DAMAGE CONTROL

INSURV SAFETY CONCERNS **AFFF SOPV**

INSURV SAFETY CONCERNS SCBA FACE PIECES

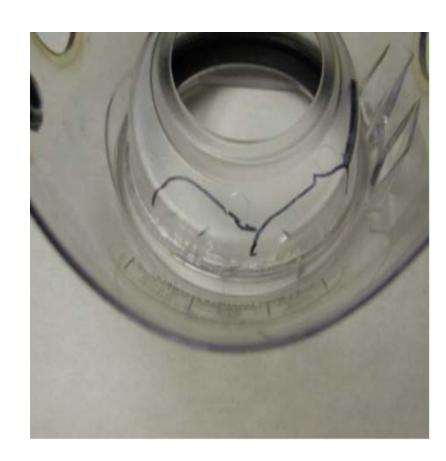
- > SCBA face pieces are cracked.
- > S/F is not identifying cracks in the SCBA face pieces.

INSURV SAFETY CONCERNS LPU-28 LIFE PRESERVER

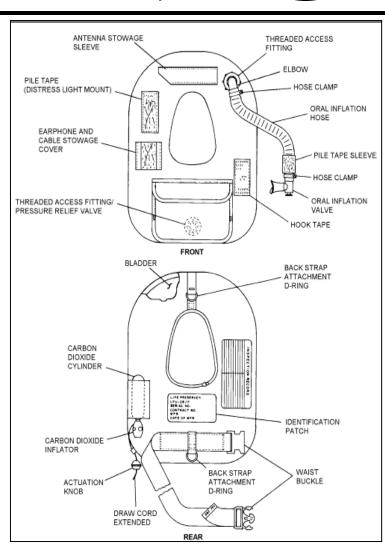
Maintenance not being performed or recorded IAW NAVAIR 13-1-6.1-2.

INSURV SAFETY CONCERNS MK1 LIFE PRESERVER

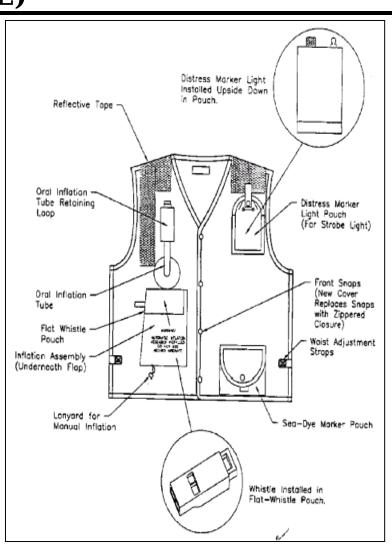
- Sea Dye Markers not installed.
- Defective C02 cylinders installed.

INSURV SAFETY CONCERNS Man Overboard Indicator

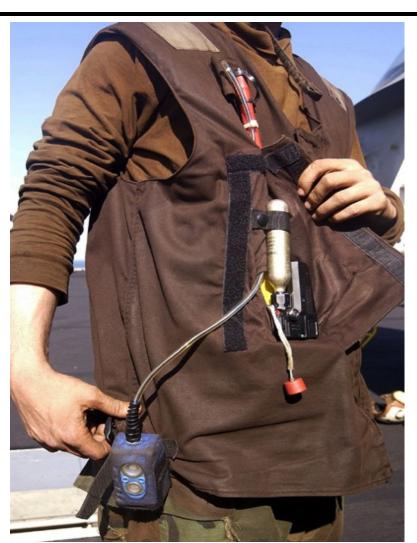
MK1/MOBI Integration being redesigned
